February 2017
FL721A-E
NHTSA #16V-656
Transport Canada #16-441
REVISED NOTICE

Subject: CNG Fuel Tank and CPDM Mounting Location

Models Affected: Specific Freightliner Cascadia vehicles manufactured September 24, 2012, through May 27, 2015, built with CNG fuel tanks

REVISION: The work instructions for all groups have been revised and further figures have been added. Some part numbers have been corrected.

Fig. 2, 1A Bulkhead Connector Pinout (view from insertion or back side of plug)

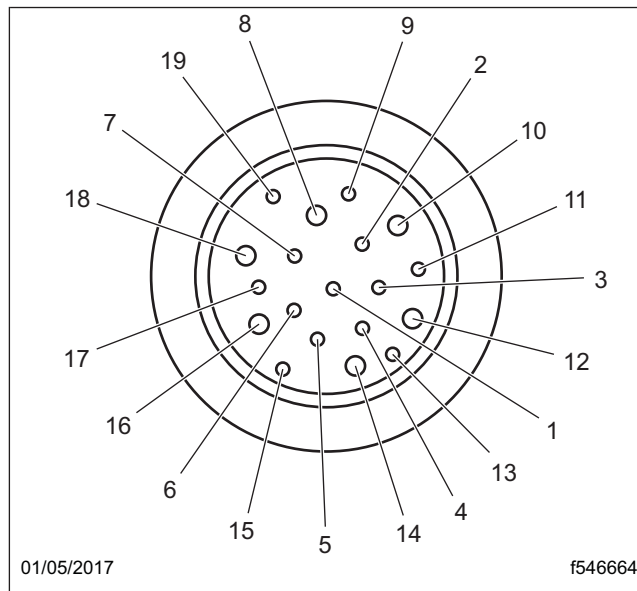
4. Insert the terminals shown in **Table 3** into their respective cavities in the dash side 1A bulkhead connector.
See **Fig. 2**.

Fig. 3, 55B Terminal Lock (released or unsnapped)

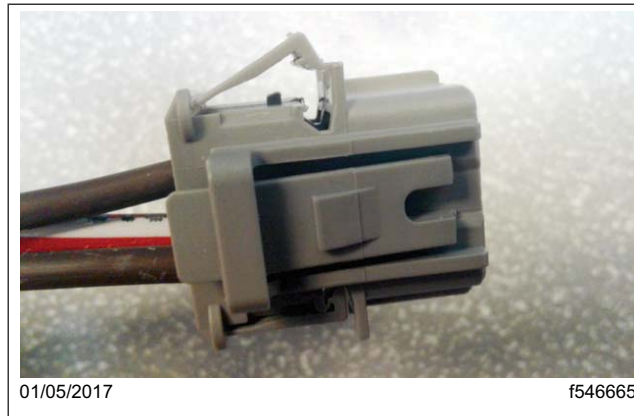
5. Unsnap the terminal lock from the only populated connector (55B) on harness A06-93000-000. See [Fig. 3](#).

Fig. 4, Circuit 45 into Connector 55B

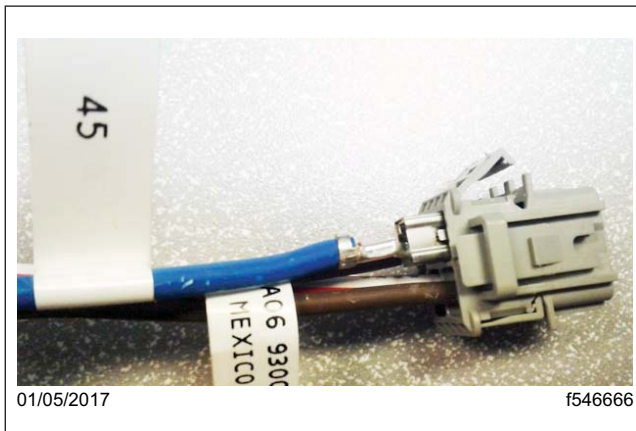
6. Insert circuit 45 (dark blue) from harness A06-93209-000 into cavity 1 of connector 55B. See [Fig. 4](#) and [Fig. 5](#).

Fig. 6, Wires Inserted into Connector 53B

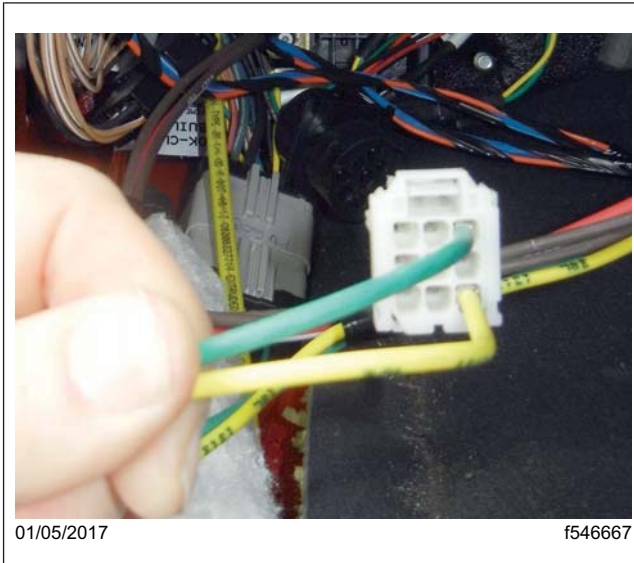
8. Insert circuits 38R (dark green) and 38L (yellow) from harness A06-93000-000 into cavities 7 and 9 respectively in connector 53B (the part is supplied loose in kit 23-13149-902). See [Fig. 6](#) and [Fig. 7](#).

Fig. 7, 52B and 53B Pinout (view from insertion point)

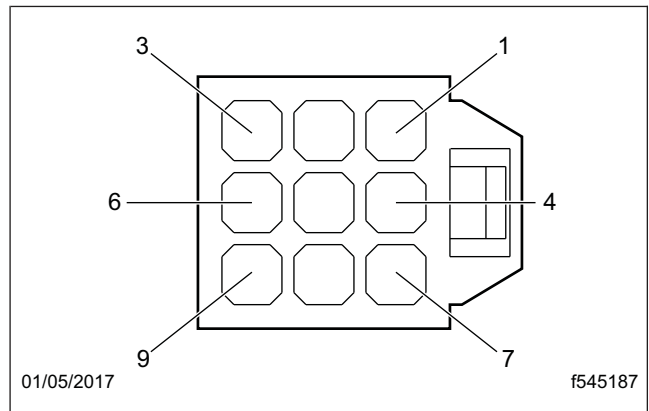
11. Unsnap the terminal lock. See [Fig. 9](#).
12. Remove the wire in cavity 6 of connector 52B. Fold the wire back against itself, and cover the terminal with heat shrink tubing. See [Fig. 7](#).

Fig. 8, SAM Chassis Connector Locations

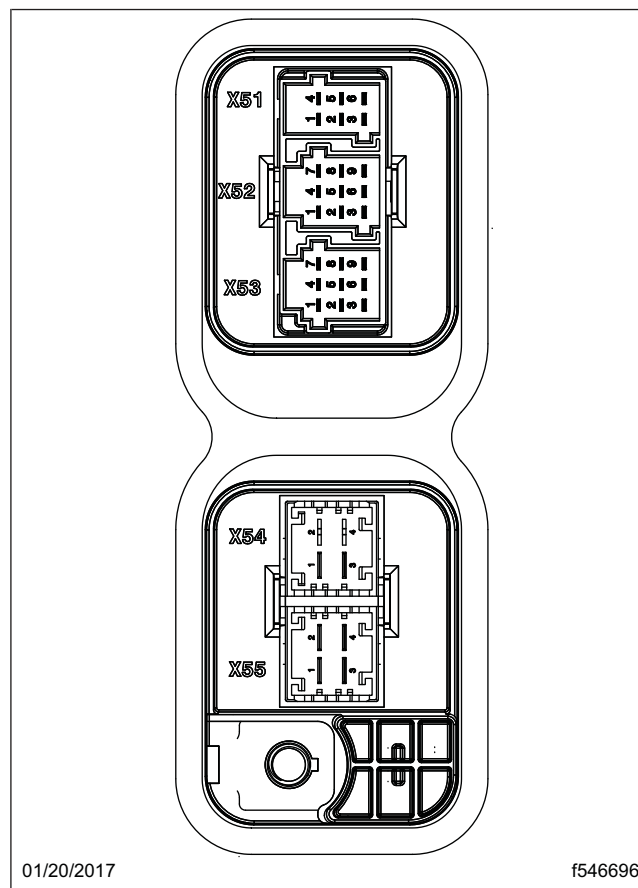
9. Snap the terminal lock and plug in the connector into cavity X53 on the SAM Chassis. See [Fig. 8](#).

Fig. 9, Removing the Terminal Lock on Connector 52B

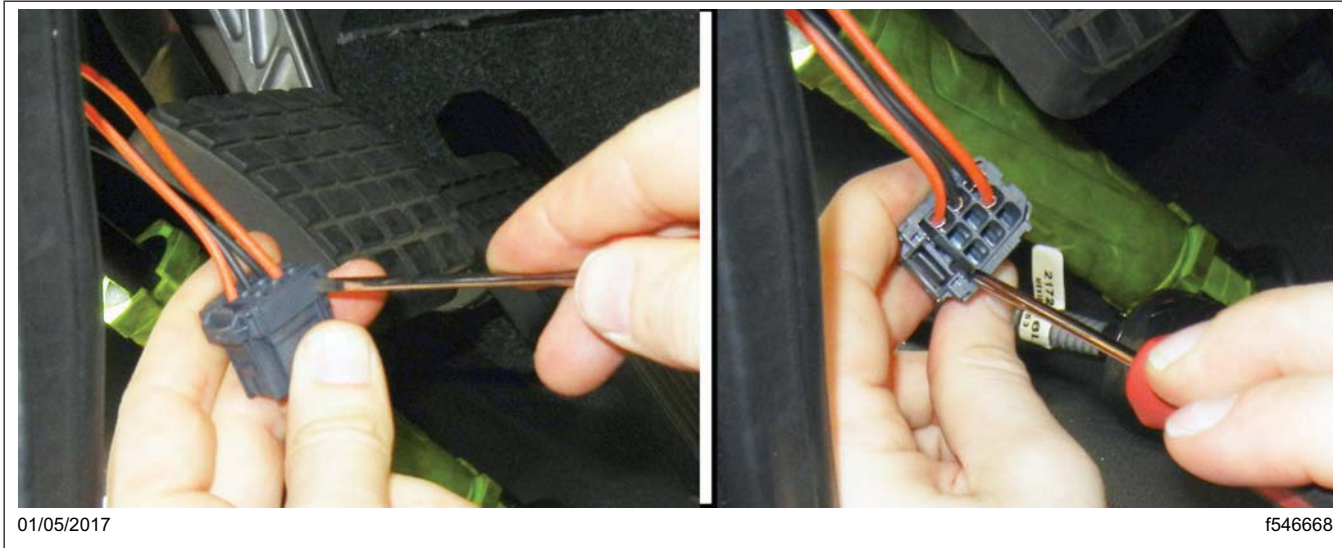
- 10. Remove connector 52B from slot X52 on the SAM Chassis.
- 11. Unsnap the terminal lock. See Fig. 9.

Fig. 10, Inserting the 4-Wire Connector into Slot X55 on the SAM Chassis

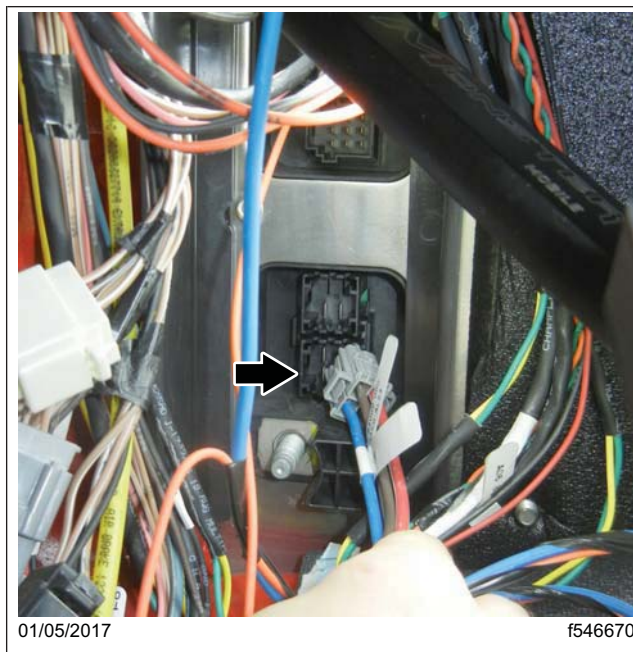
- 12. Remove the wire in cavity 6 of connector 52B. Fold the wire back against itself, and cover the terminal with heat shrink tubing. See Fig. 7.
- 13. Label the wire with tape with the description "Removed for FL721."
- 14. Insert circuit 376C (orange) from harness A06-93209-000 into cavity 6 on connector 52B. See Fig. 7.
- 15. Snap the terminal lock and plug the connector into slot X52 on the SAM Chassis.
- 16. Plug the 4-wire connector on harness A06-93000-000 into slot X55 on the SAM Chassis. See Fig. 10.

Fig. 16, 2A ICU Heat Shrink

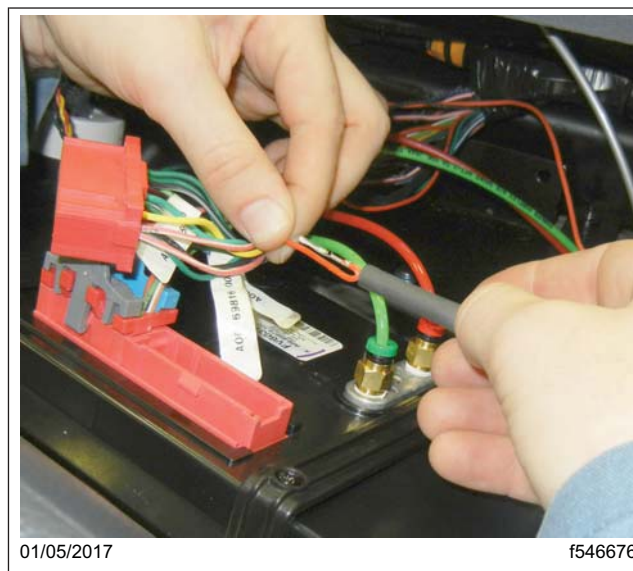
22. Fold the wire back against itself, and cover the terminal with heat shrink tubing. See [Fig. 16](#).

Fig. 30, Wrapping the Harness with Fiber Tape

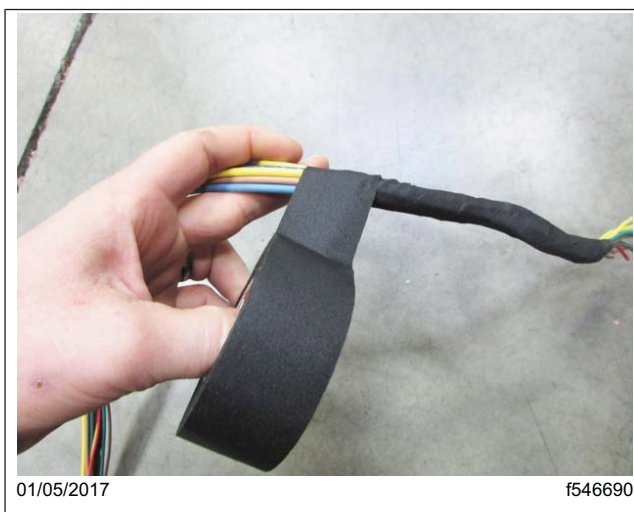
37. Wrap the exposed section of harness (A06-93018-084) with fiber wrap tape (48 25910 003). See [Fig. 30](#).

Fig. 31, Bulkhead Harness Routing

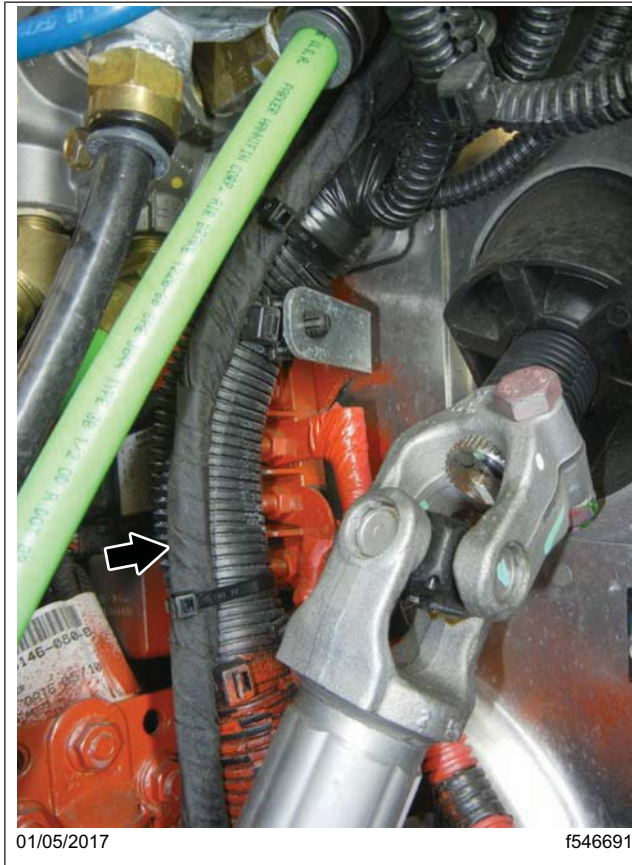
38. Route harness A06-93018-084 along the frame rail to bulkhead connector 1A. See [Fig. 31](#).

Fig. 34, Primary Receptacle Pinout

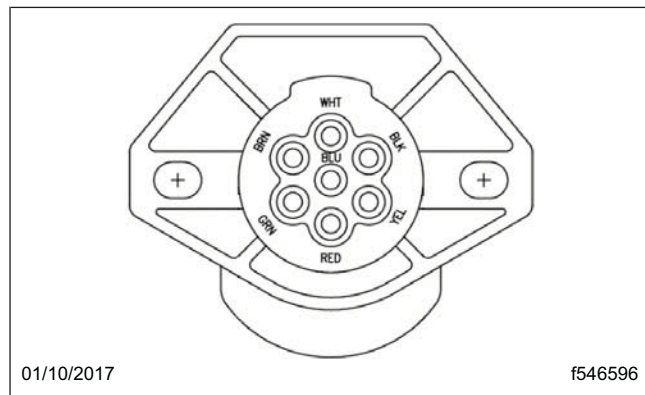
- **End-of-Frame Receptacle Power:** A0004478661-001 PARM-CHAS,EOF,SUP-R,NO CNT
 - **Trailer Configuration:** A0014470261-001 PARM-CHAS,TRA,BOC,IGN
49. Verify that the primary receptacle (**Fig. 34**) is functioning properly by performing the following checks with the ignition key in the ON position:

- 49.1 Verify there is battery voltage on the Black terminal while the marker lamps are turned on.
 - 49.2 Verify there is battery voltage on the Brown terminal while the headlamps are turned on.

- 49.3 Verify there is battery voltage on the Green terminal while the right turn signal is activated.
 - 49.4 Verify there is battery voltage on the Red terminal while the service brake is activated.

- 49.5 Verify there is battery voltage on the Blue terminal at all times.
 - 49.6 Verify there is battery voltage on the Yellow terminal while the left turn signal is activated.

Fig. 35, Wire Inserted into Connector X1A

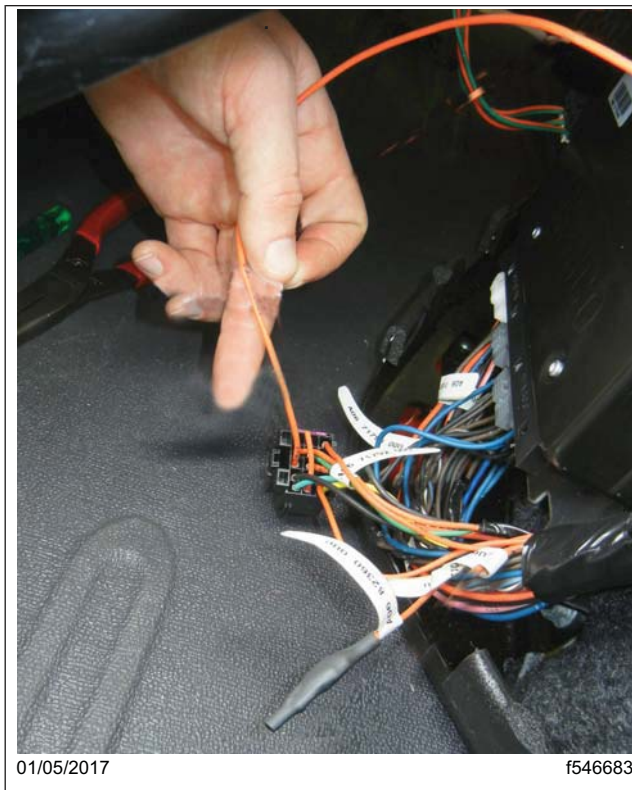
25. Insert the free ends of single-wire harness A06-93668-000 into ABS module connector X1A, cavity 7. Connect A06-93668-000 into cavity 7. See [Fig. 35](#)

Fig. 36, Pinning From

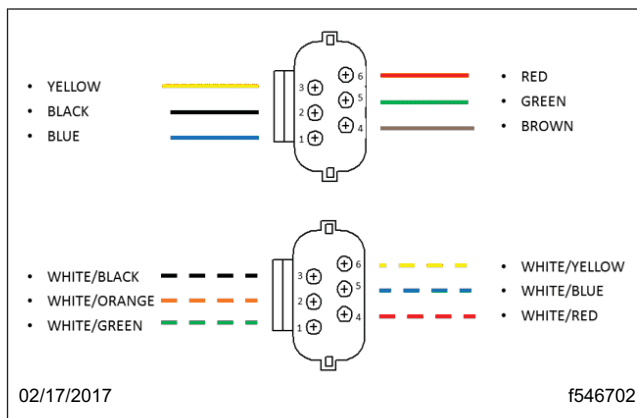
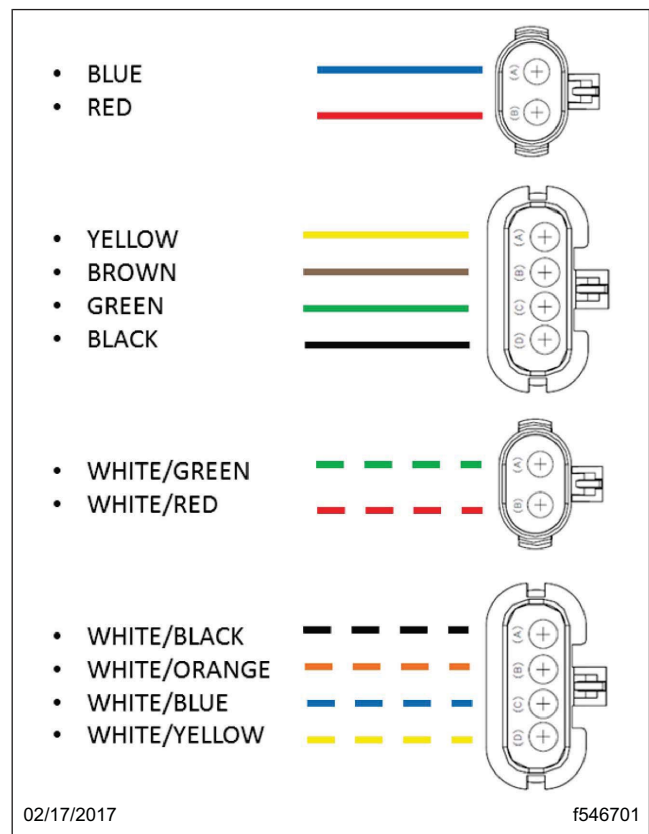
Primary Receptacle Connectors					
Receptacle	Wire Color	Seal	Terminal	Connector	Terminal Lock
Primary	Red	23-12497-010	23-13213-332	23-13302-033	23-13142-218
	Blue	23-12497-010	23-13213-332	23-13302-033	23-13142-218
	Yellow	23-12497-001	3-13213-131	23-13302-091	23-13142-404
	Brown	23-12497-001	3-13213-131	23-13302-091	23-13142-404
	Green	23-12497-001	3-13213-131	23-13302-091	23-13142-404
	Black	23-12497-001	3-13213-131	23-13302-091	23-13142-404
Supplemental	White/Green	23-12497-010	23-13213-332	23-13302-033	23-13142-218
	White/Red	23-12497-009	23-13213-330	23-13302-033	23-13142-218
	White/Black	23-12497-000	23-13213-131	23-13302-091	23-13142-404
	White/Orange	23-12497-000	23-13213-131	23-13302-091	23-13142-404
	White/Blue	23-12497-000	23-13213-131	23-13302-091	23-13142-404
	White/Yellow	23-12497-000	23-13213-131	23-13302-091	23-13142-404
